Access Compliance Report

Public Rights-of-Way

(Pedestrian Signals)

Intersection ID: N/A	Main Street:	Cross Street: N/A	Location: N/A
ADA ID: 073D3A94F8B1	Signal Type: One Push Button-Non APS	Overall Compliance: No	Severity Score: BTN 1: N/A BTN 2: N/A No BTN: N/A
Codes/Mitigation Info/Possible Solution		Field Measurements/Component Compliance

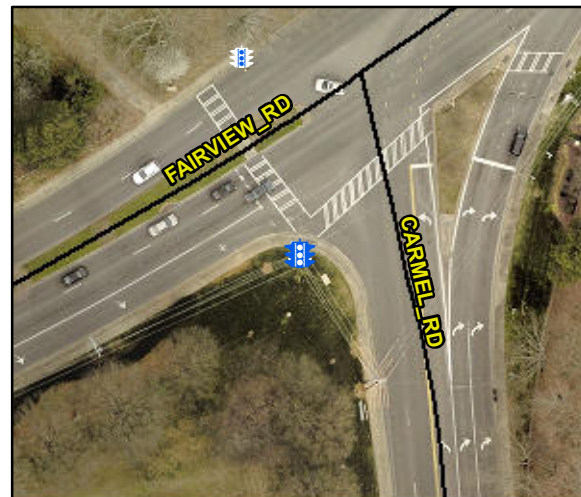
PROW/ADA: TMUTCD 4e.08, R404.3, R404.1, R404.7.1, R404.7.2

Yes	B 1 Clear Xing Direction?	ClearlyMarked	N/A	B 2 Clear Xing Direction?	N/A
	B 1 Crossing Direction	To NW		B 2 Crossing Direction	N/A
No	B 1 DistanceTo XWalk (in)	130.0	N/A	B 2 DistanceTo XWalk (in)	N/A
No	B 1 DistanceTo Curb (in)	135.0	N/A	B 2 DistanceTo Curb (in)	N/A
Yes	B 1 Diameter (in)	2.0	N/A	B 2 Diameter (in)	N/A

Possible Solutions: Replace Signal Push Button With APS Button on New Post. Remove & Relocate Sign.
